# Access Compliance Report

## Public Rights-of-Way

### (Curb Ramps)

Intersection ID: 10012666	Main Street: RUTHERGLEN_CT	Cross Street: N/A	Location: NW
ADA ID: 74CFA873ADE8	Ramp Type: Perp	Initial Pass/Fail: Fail	Overall Compliance: No
Severity Score: 35			
Codes/Mitigation Info/Possible Solution		Field Measurements/Component Compliance

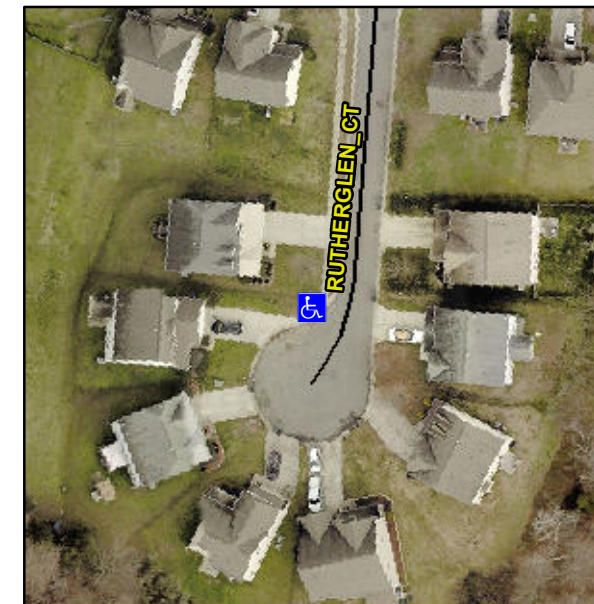
**Not Found, R304.5.1, R304.2.2, R304.5.3**

Compliance	Description	Data	Compliance	Description	Data
N/A	Ramp Length (in)	48.0	No	Ramp Slope (%)	12.8
No	Ramp Width (in)	44.5	No	Ramp XSlope (%)	3.5
N/A	Flare Type LT	N/A	N/A	Flare Type RT	N/A
N/A	Flare Slope LT (%)	N/A	N/A	Flare Slope RT (%)	N/A
N/A	Flare Traversable LT?	N/A	N/A	Flare Traversable RT?	N/A
N/A	Landing Length (in)	N/A	N/A	DWS Provided?	N/A
N/A	Landing Width (in)	N/A	N/A	DWS Contrast?	N/A
N/A	Landing Slope (%)	N/A	N/A	DWS Length (in)	N/A
N/A	Landing X Slope (%)	N/A	N/A	DWS Full Width?	N/A
N/A	Landing Curb? (Y/N)	N/A	N/A	DWS Offset (in)	N/A
N/A	Shared Landing?	N/A			
N/A	Gutter Ponding?	N/A	N/A	Gutter Slope (%)	N/A
N/A	Gutter Lip Ht (in)	N/A	N/A	Gutter X Slope (%)	N/A
N/A	Painted X Walk1?	No	N/A	Painted X Walk2?	N/A
	X Walk 1 Direction	To SE		X Walk 2 Direction	N/A
N/A	X Walk 1 Width (in)	N/A	N/A	X Walk 2 Width (in)	N/A
	X Walk 1 Slope (%)	0.2		X Walk 2 Slope (%)	N/A
	X Walk 1 X Slope (%)	1.7		X Walk 2 X Slope (%)	N/A

**Remove & Replace Entire Ramp.**
